Detailed Site Plan Departure from Sign Design Standards Maryland 95 Corporate Park, Redevelopment of Lot 20

**DSP-98039-04
DSDS-25001**

SUBJECT: Detailed Site Plan DSP-98039-04
Departure from Sign Design Standards DSDS-25001
Type 2 Tree Conservation Plan TCP2-2025-0071
Maryland 95 Corporate Park, Redevelopment of Lot 20

Figure 1: Front Elevation (Northeast)

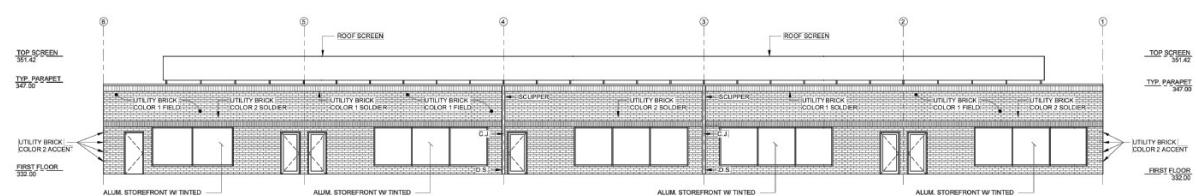
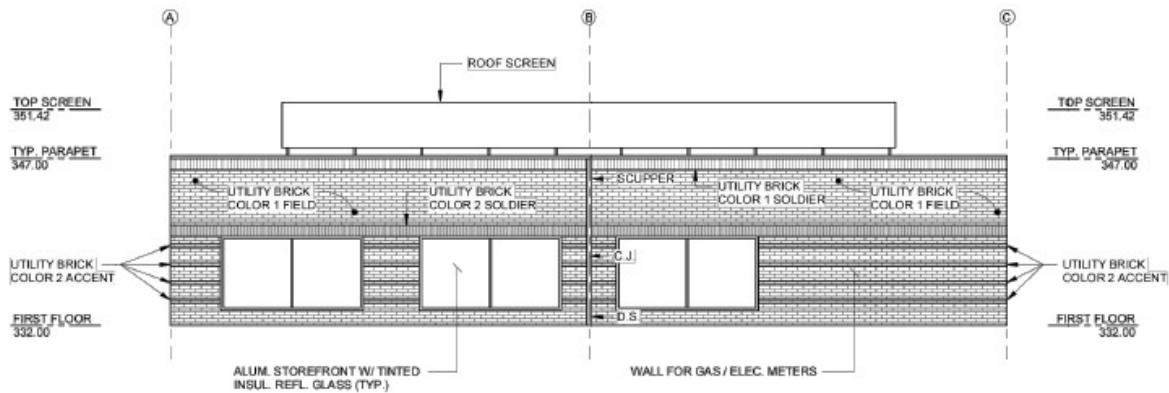
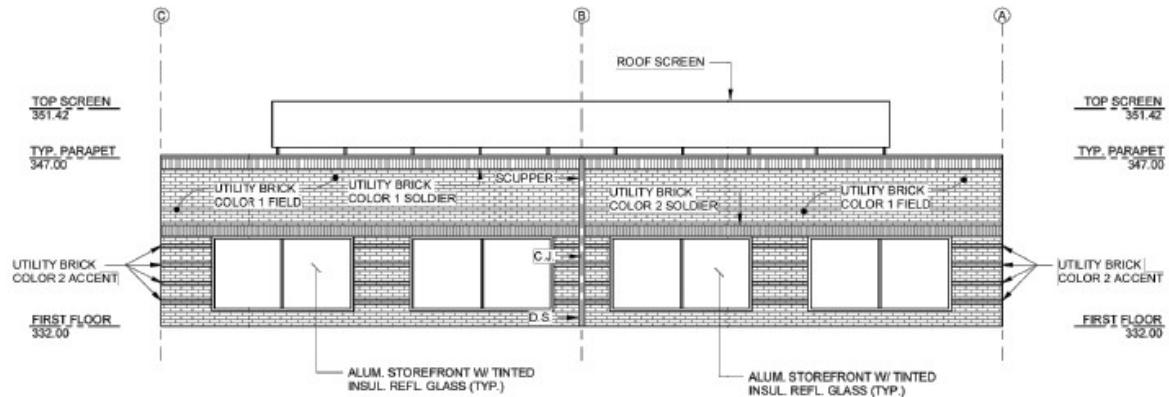
The proposed day care building is a single-story, rectangular commercial structure featuring a contemporary design characterized by clean horizontal lines, a cohesive masonry palette, and balanced fenestration on all elevations. The façade incorporates two complementary brick colors, with horizontal and vertical accent bands, that closely reflect the architectural character of the adjacent existing office building. Specified materials include Glen-Gary "Brookshire" brick for the primary field and "Canyonstone" for accent detailing, reinforcing the horizontal expression of the design.

All elevations integrate aluminum-framed, tinted reflective glass arranged in continuous horizontal bands, interrupted only by building mass and entry doors. The front façade is distinguished by three vertical brick extensions rising above the roofline, to emphasize entrance locations. Mechanical equipment will be screened from view by roof-mounted enclosures.

- a. Provide dimensions on elevations.
 - b. Provide location and details of the building-mounted light fixtures for the proposed day care center for children, in conformance with Section 27-562 and 27-274(a)(3)(A) of prior Prince George's County Zoning Ordinance.

Figure 5: Site Cross-Section Exhibit

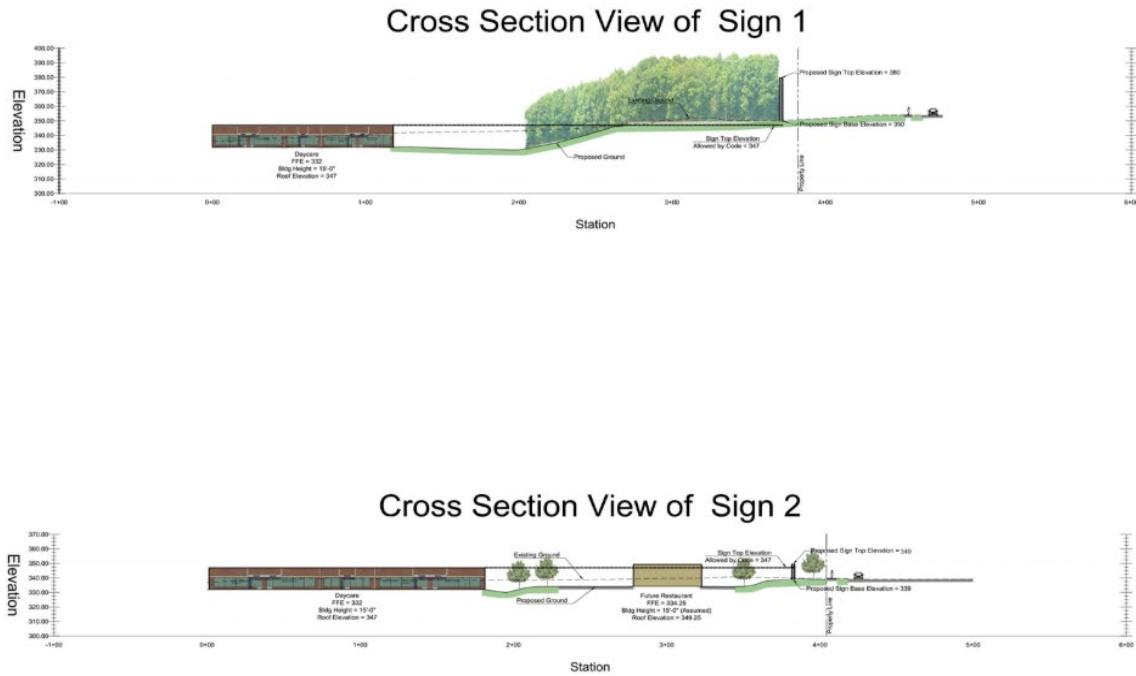
The applicant further asserts that the proposed 30-foot height of the Konterra Drive sign represents the minimum necessary to ensure adequate visibility and legibility of the sign, with the 40 mile per hour speed limit on Konterra Drive, distance of the sign from the roadway, and the existing tall vegetation to remain around the sign. Though Lot 22 does not actually abut Konterra Drive, due to the adjacent lot configuration, the applicant takes into consideration the "perceived" frontage, from both Sweitzer Lane and Konterra Drive. This perceived frontage takes into account the frontage along Sweitzer Lane and Konterra Drive, if not for the abutting lots which form a narrow strip of land between Lots 22 and the ROW. The site's topography creates a circumstance in which the elevation at the intersection of Sweitzer Lane and Konterra Drive is higher than the existing and proposed buildings, impeding upon the awareness and identification of the development from the intersection and, as the applicant believes, contributes to the vacancy of the existing office building in the development. Staff find that provided signage that departs from the standards represents the minimum necessary, given the specific circumstances of the request.
